City of Portland, Maine – Building or Use Permit Application 389 Congress Street, 04101, Tel: (207) 874-8703, FAX: 874-8716

ADDRESS: 1435 Congress St DATE: 1/20/99
REASON FOR PERMIT: interior renovations - to garage entry way
BUILDING OWNER: Man S Vay C-B-L: 194-C-30
PERMIT APPLICANT: owner
APPROVED: with conditions DENIED: _____
#5; #9

DATE: 21 Jan. 98 ADDRESS: 1435 Congress ST
REASON FOR PERMIT: To make interior renovation to garage entryway
BUILDING OWNER: Man Svay
CONTRACTOR: Owner
PERMIT APPLICANT: Man Svay APPROVAL: _____ ~~DENIED~~
USE GROUP R-3 BOCA 1996 CONSTRUCTION TYPE 5B

1435 CONGRESS ST. 9' WALL GOING TO TAKE OUT

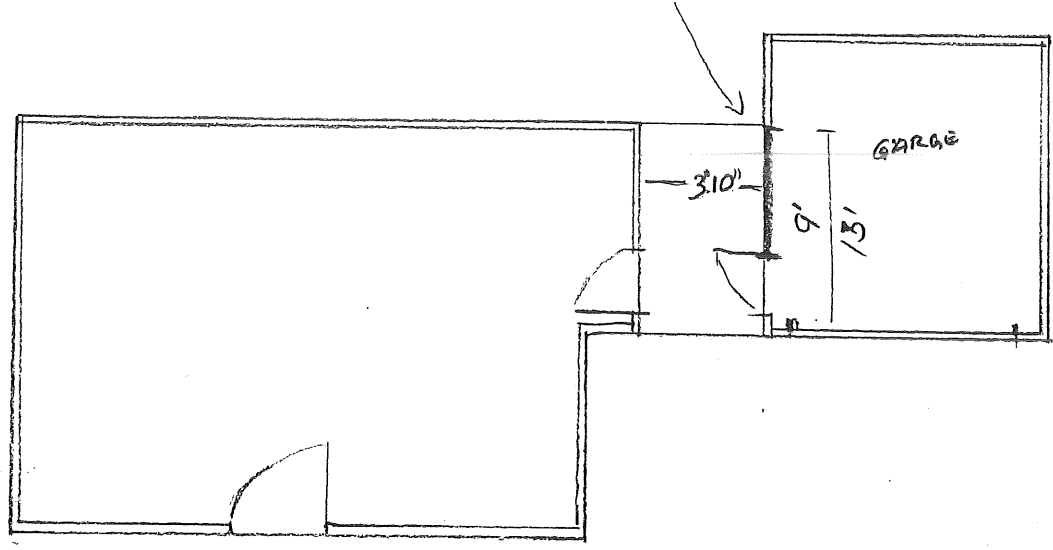
- X30. Please read and implement attached Land use - Zoning report requirements.
- X31. Your plan shows that you propose to remove a bearing wall. This permit is being issued ~~before~~ before the wall is remove that you have a professional design person design the new carrying beam. NO work is to be done in this area until you have submitted and have the approval of this office for the proposed beam. (2-2x8 will NOT carry the new load).
